Planning Commission Staff Report

Subject: Treasure Project #: PL-08-00370

Type of Item: Administrative – Conditional Use Permit

Refinement 17.2 Update

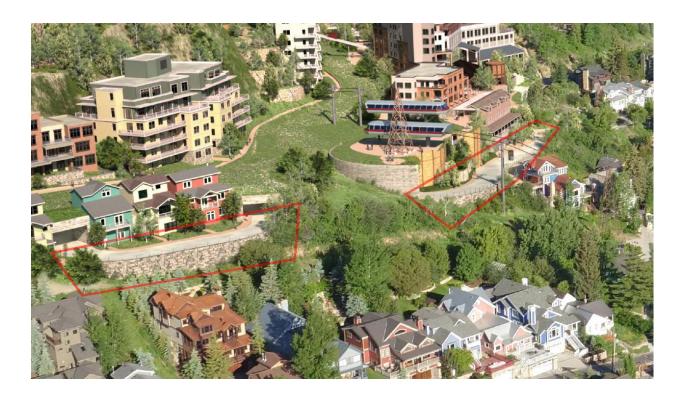
Staff is specifically concerned with the first listed setback exception as it restricts (retaining) walls to no more than four feet (4') in height (measured from final grade). Supplemental Regulations (LMC 50th Edition) Chapter 4 § 15-4-2(A) reiterates the same regulation listed under the exception as it also clarifies that through an administrative CUP approval (reviewed by the Planning Commission) a retaining wall may exceed six feet (6').

Refinement 17.2 contains a driveway accessing the site from the Lowell-Empire switchback parallel to Building 2 extending below the ski lift which enters into an underground passage towards an en exposed driveway parallel to Building 1A before returning again to another tunnel towards the underground parking structure underneath Building 1A, 1B, and 1C. This entire driveway from Creole-Gulch site extending towards Mid-Station site is supported by a retaining wall on its east side which exceeds the maximum retaining wall exception of four feet (4'). In conjunction with this CUP the Planning Commission can further approve the maximum height (measured from final grade) of this proposed retaining walls, additionally the Applicant has not request an exception. Staff is unable to verify the exact height of this wall based on the submitted plans of Refinement 17.2; however, it can easily be determined that this proposed retaining wall will be over four feet (4') from final grade. See rendering below with the identified retaining walls areas over four feet (4'):

Does the Planning Commission agree with staff analysis which designates the front setback area the same as the delineated 0'-0" maximum building height area? Does the Planning Commission agree with staff that the same front yard exception outlined in the Estate District would apply to the Creole-Gulch and Mid-Station sites?
